ADA Curb Ramp New Construction Inspection Form (Perpendicular)

Nw 294th

Project No.

Nw 292nd

PERPENDICULAR RAMP (PR)

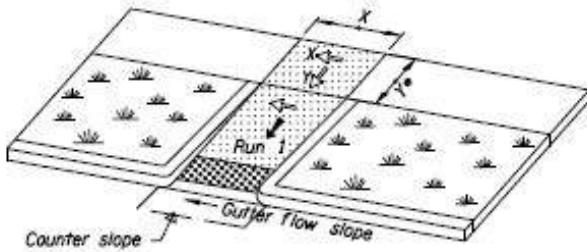
IITD RR1 fails
